REQUEST

Current Zoning: R-3 (single family residential)
Proposed Zoning: MX-2 (INNOV) (mixed used, innovative) with five-year vested rights

Approximately 36.7 acres located on the south side of Ardrey Kelly Road, west of Wade Ardrey Road and east of Travis Gulch Drive. (Council District 7 - Driggs)

The petition proposes redevelopment of seven parcels with five single family homes with a mixed residential community including single family lots and up to 205 townhome units for a total of 220 dwelling units.

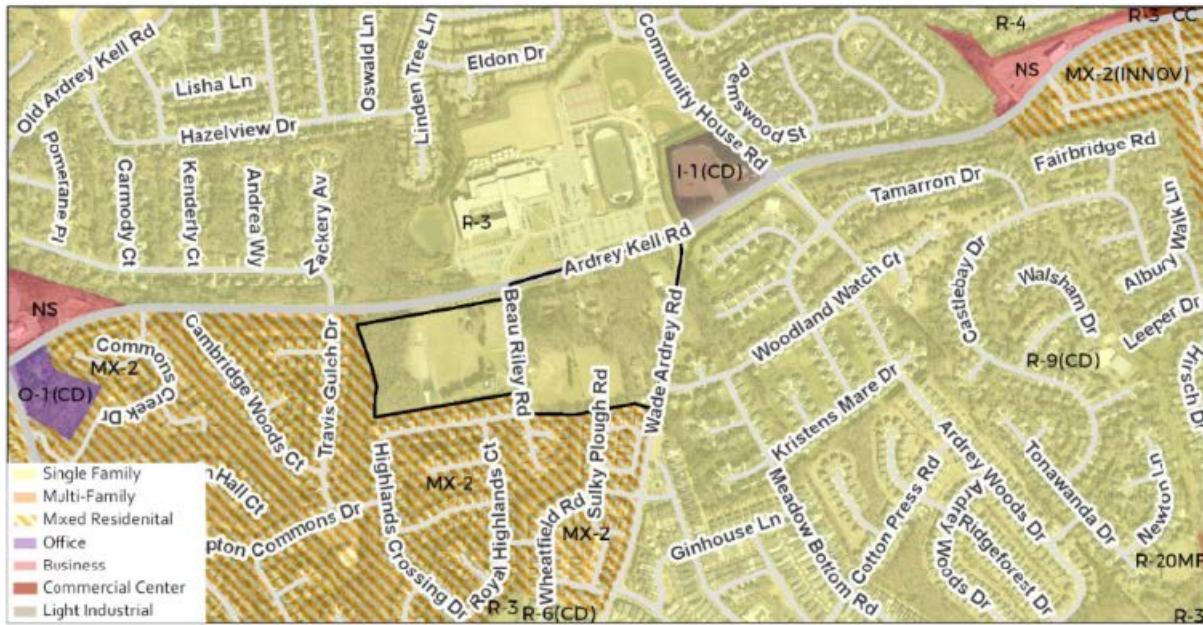
4. ~~Amend note 6 under Streetscape, Landscaping, and Open Space to specify that the front of the sidewalk along Ardrey Kell Road shall be installed 49 feet from the centerline. Amend the site plan to label the future back-of-curb for Ardrey Kell 42.5 feet from existing centerline to accommodate half of a four-lane divided cross section with 16-foot median, 12-foot travel lanes, 8-foot buffered bike lane, and 2.5-foot curb and gutter. Specify that future curb lines for Wade Ardrey Road and Beau Riley Road will follow the local collector cross section (CLDSM U-07).~~ **Addressed**.

5. ~~Delete all occurrences of the following note on sheet RZ-2 "Size and shape of pond/BMP facility to be determined during final engineering. If during final engineering design it is determined that the pond is not required it can be removed from the plan."~~ **Addressed**.

6. ~~Revise note 4 under Section IV Transportation to address all/any site access public street connections.~~ **Addressed**.

7. ~~Amend the site plan exhibit to remove the extra townhome unit shown on one lot, north of the amenity area showing a clubhouse.~~ **Addressed**.
8. ~~Remove the buffer hashing that is shown across the connection to Sulky Plough Road.~~ **Addressed**.

9. ~~Amend Innovative standard III note 1 to specify that front loaded, attached townhome units will provide a garage setback of 20-feet from the back of the sidewalk.~~ **Addressed**.

10. ~~Delete the words "as generally shown on the rezoning plan." from section V Architectural Standards Note 4 that specifies sidewalks will connect front doors of townhome units to the sidewalk network.~~ **Addressed**.

11. ~~Elaborate Section V Architectural Standards note 6 to explain how blank walls will be broken up, for example through the use of a combination of doors, windows, change of materials, awnings, articulation, change of plane etc.~~ **Addressed**.

12. ~~Delete Note 3 under section VI Streetscape, Landscaping and Open Space related to setbacks as these are covered under the proposed Innovative standards.~~ **Addressed**.

13. ~~Delete Note 9 under section VI Streetscape, Landscaping and Open Space related to screening for the alleys as the alleys will be screened by the 30-foot buffer, landscaped to Class C standards, provided along Ardrey Kell Road and Wade Ardrey Road.~~ **Addressed**.
